SUBJECT: Core Operating Limits Report (COLR) Cycle 23 Revision 1 for Grand Gulf Nuclear Station, Unit 1 (GGNS)

Grand Gulf Nuclear Station, Unit 1
Docket No. 50-416
Renewed License No. NPF-29

Revision 1

REASON FOR REVISION

Figure 4 Backup Stability Protection Region Boundaries for Normal Feedwater Temperature (NFWT)

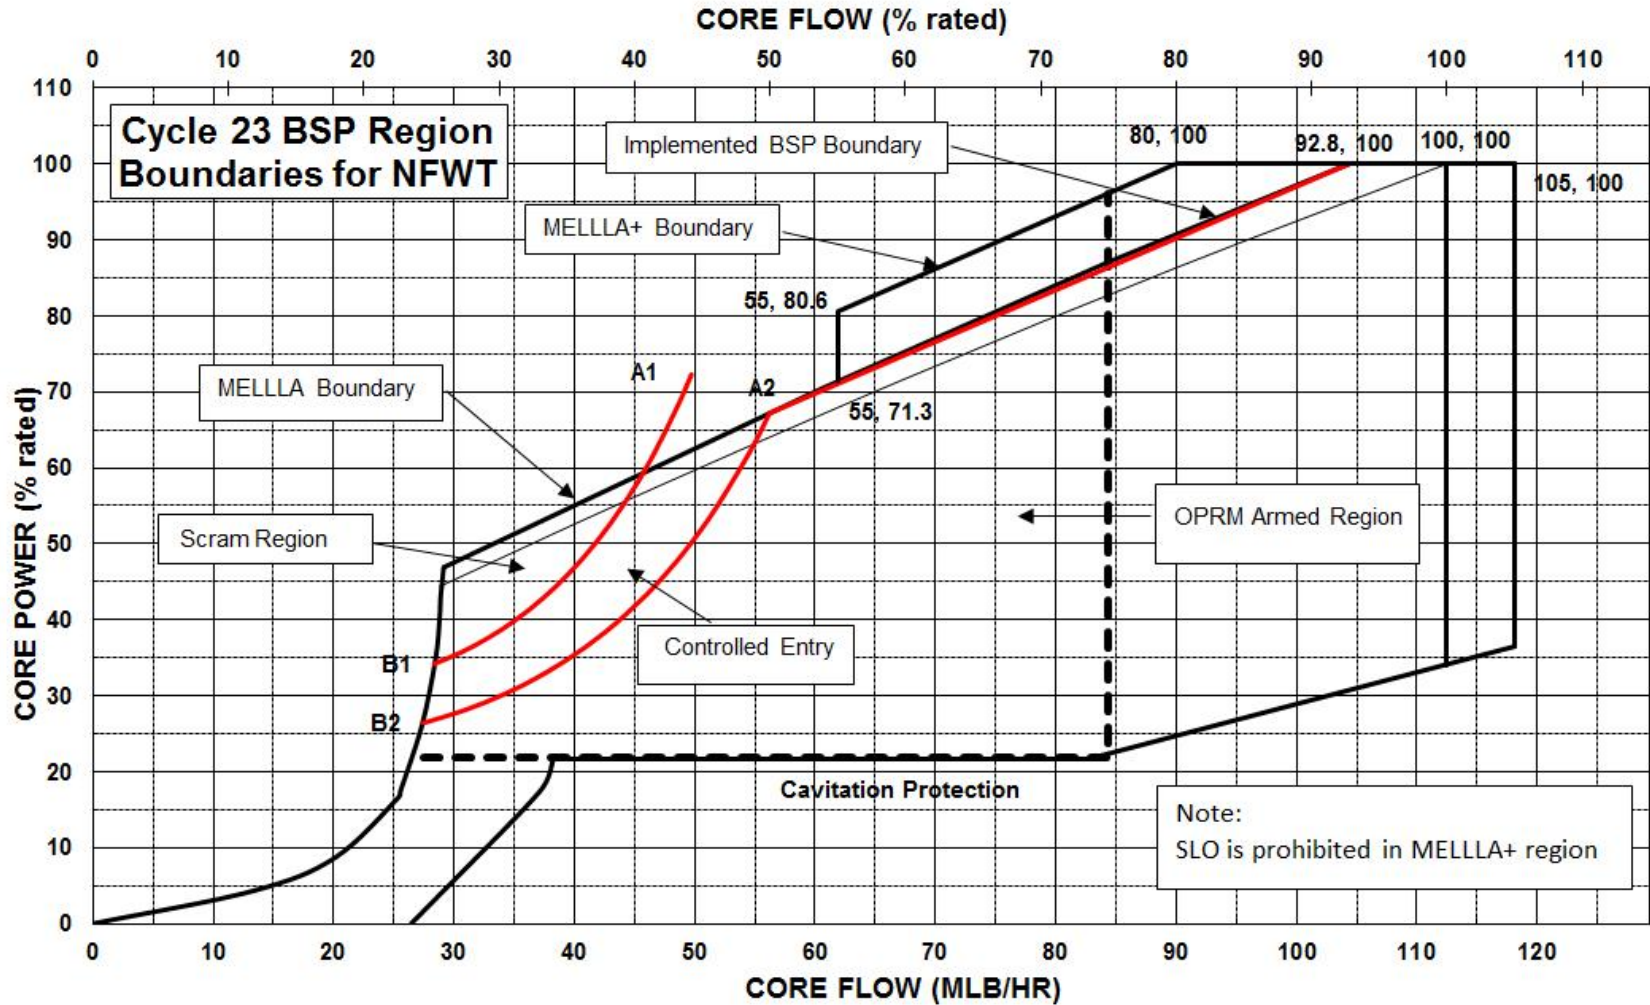
The Cycle 23 core operating limits are revised to replace the BSP region boundaries for RFWT (Figure 5) with a corrected figure for Cycle 23. Cycle 23 COLR Revision 0 Figure 5 was still showing Cycle 22's BSP region boundaries for RFWT. Figure 4 was updated to remove A3 and B3 labels which are not provided in Table 2.
